PRATT & WHITNEY CANADA
SERVICE BULLETIN

P&WC S.B. No. 1669R9

TURBOPROP ENGINE
COMPRESSOR TURBINE BLADES - INSPECTION/REPLACEMENT OF

PT6A-114, PT6A-114A

CT Blade Tip Grinding
Figure 1

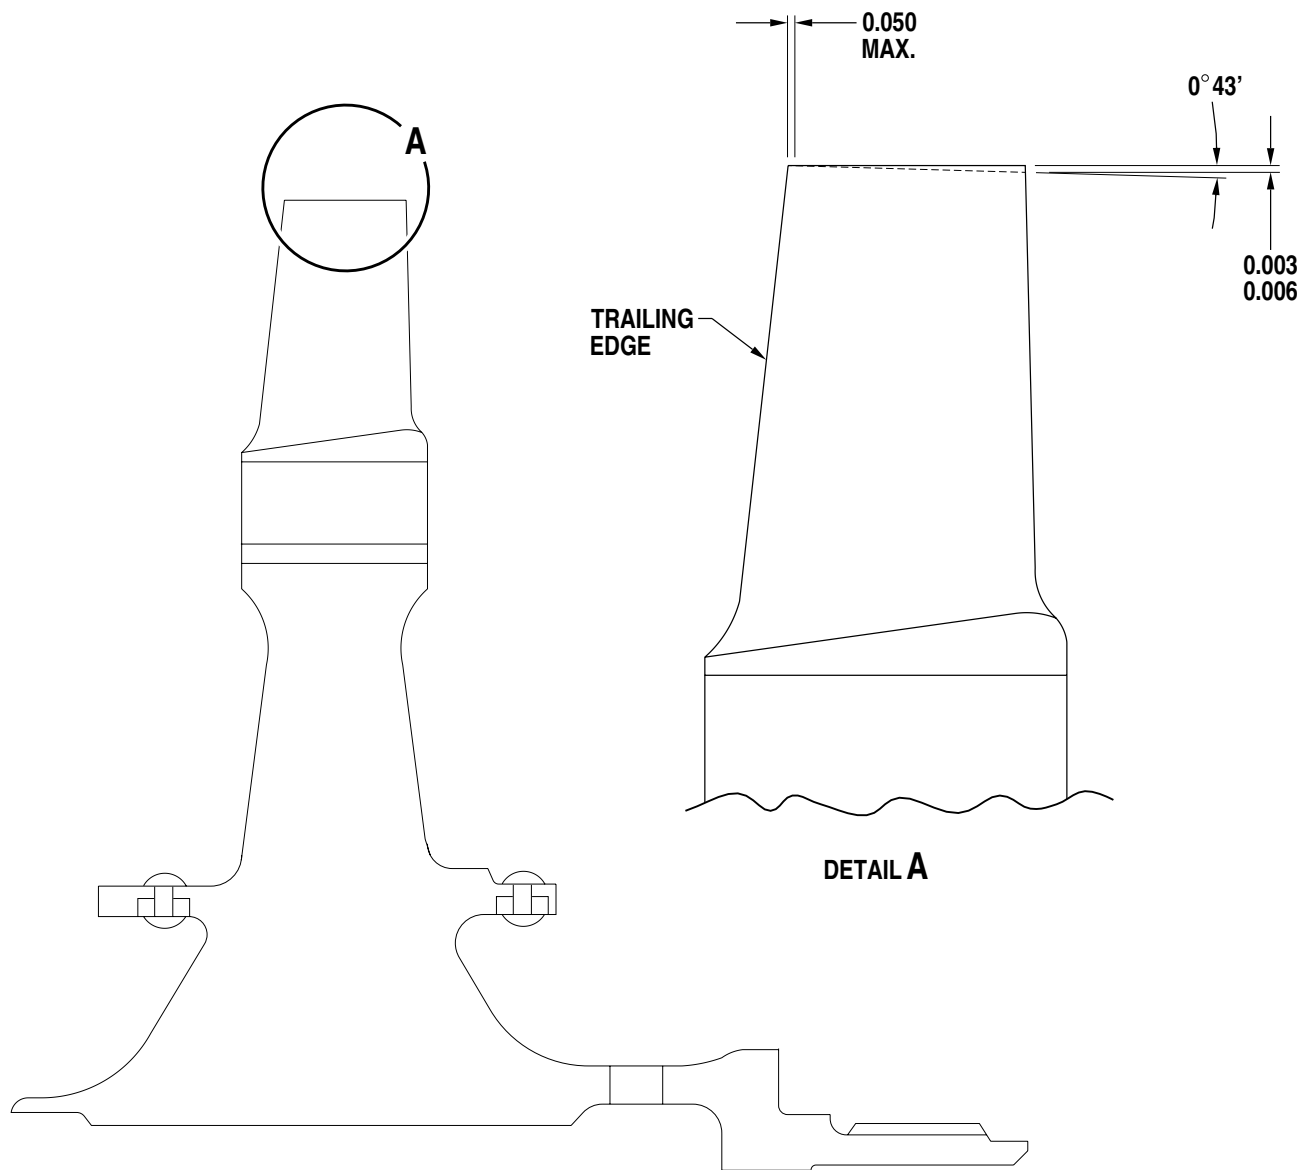
- (3) Implement conical grinding of the new CT blades per the applicable overhaul manual instructions with the differences that follows:
 - (a) Incorporate 0°43' taper (Ref Fig. 1).
 - (b) If necessary replace the segments to get the correct Fit and Clearance No. 318. Refer to the applicable maintenance or overhaul manual instructions.
- (4) Install the parts listed under New P/N in Para. 2.C., Material Information. Refer to the applicable maintenance or overhaul manual instructions.

CT Disk - Fits and Clearances
Figure 2

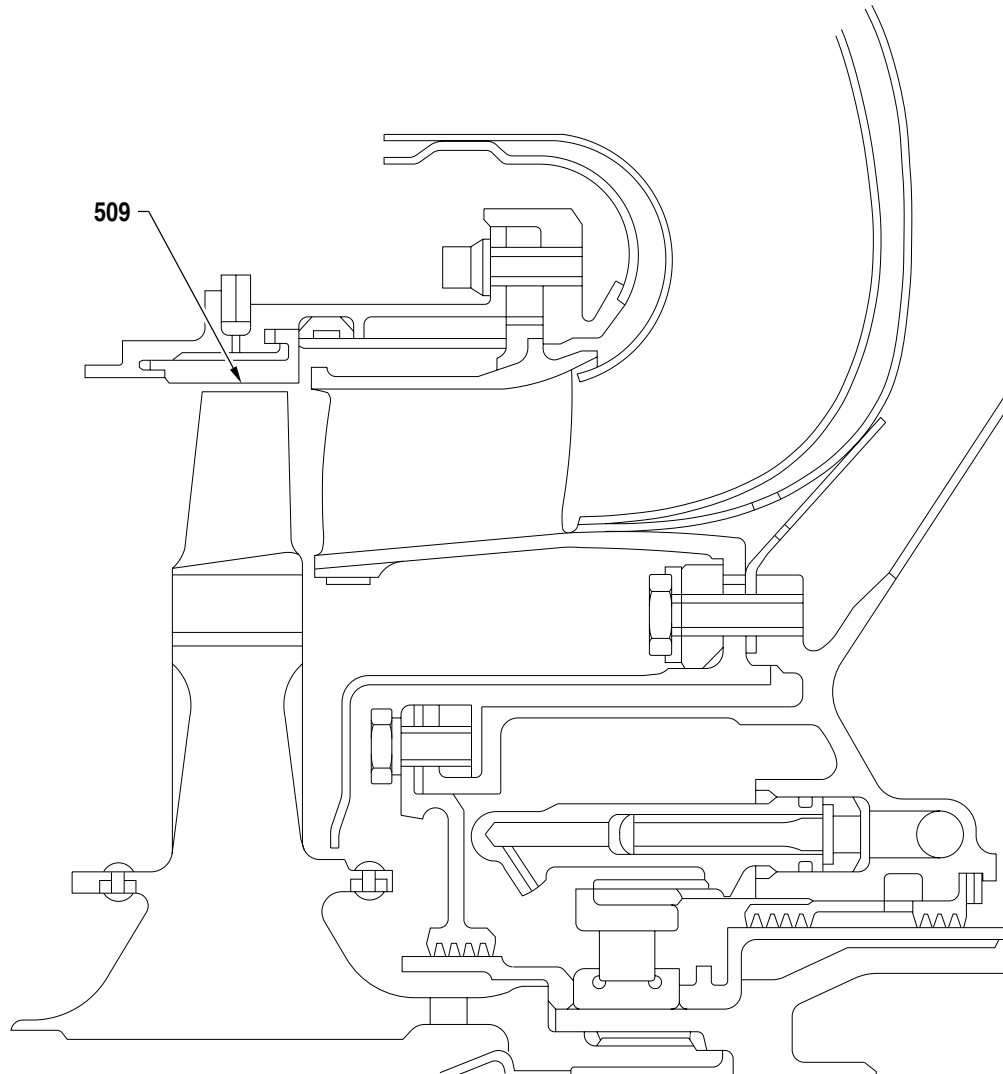
A. Refer to the Fits and Clearances Fig. No 2.

REF. NO.	IFR	Name	Dim. for Ref. inches (mm)		Limits inches (mm)		Replace
			Min.	Max.	Min.	Max.	
Post-SB1669							
509		Turbine Rotor Diameter (Green Run)			8.526 (216.56)	8.536 (216.81)	
509		Turbine Rotor Diameter (Overhaul)					8.496 (215.80)
